**Re: Other Change Development Application - MCU/2022/588 - 776 Pacific Parade, Currumbin**

I refer to your instructions to review the Other change development application with a focus on establishing the level of assessment of the application, based on the number of storeys proposed. This advice focuses solely on that aspect of the application and does not extend to a review of the merits of the application.

Interpretation of number of storeys – 776 Pacific Parade, Currumbin

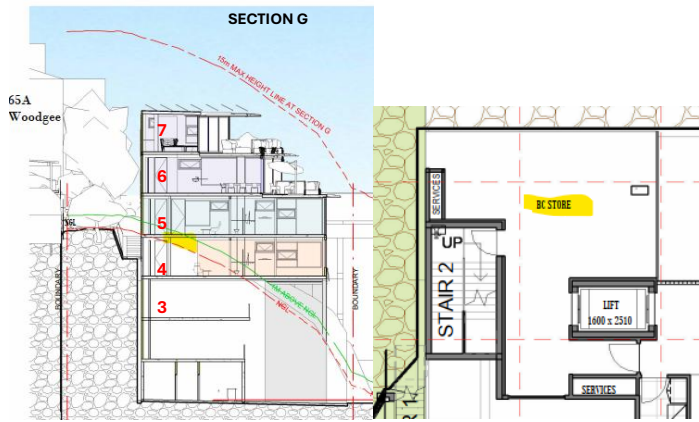
Section F below shows a small section of the lift overrun (highlighted yellow below) which extends beyond 15m above ground level. An additional section (between Section F & G) is required along with an RL in relation to the lift overrun to determine whether the building height exceeds 15m in this part of the building and therefore triggers impact assessment.

Level 7 - At Section E & G, this level constitutes a 'storey' as it includes a bedroom and ensuite and therefore is not only a space used for a lift shaft, stairway, meter room, bathroom, shower room, laundry, toilet or other sanitary compartment. See Page 2 below.

A BC Store (i.e. storage area) is proposed on Level 03 which is excluded from the definition of 'storey'. This area is identified in yellow on the floor plan and Section G below. As such, **4 storeys** is proposed within this section of the building and triggers impact assessment.

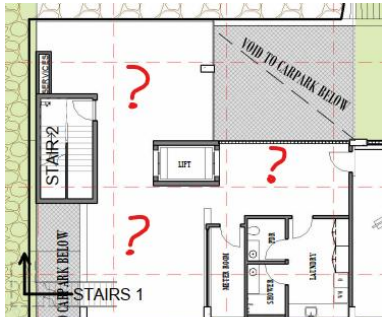
Whilst this area comprises stairs, lift, meter room, shower, PDR and laundry (which are excluded from the definition of 'storey'), there are areas that are not labelled (see areas identified in question mark on image below) that are in excess of space that would be reasonably required to access the lift and stairs. This space could be used for a purpose other than that excluded from the definition of a 'storey' i.e. storage or additional living space for instance. Therefore, depending on the intent of use of this space, the area of the building identified in pink above is **4 storeys**.

The small area shown in blue below does not meet the definition of 'basement' and is essentially a 'storey'. This is because a 'basement' (which is excluded from the 'storey' definition) is defined as a space between a floor level in the building and the floor level that is immediately below it with no part more than 1m above ground level. As this space exceeds 1m above ground level, this part of the building is not a basement and constitutes a 'storey'. Therefore this section of the building is **5 storeys**.
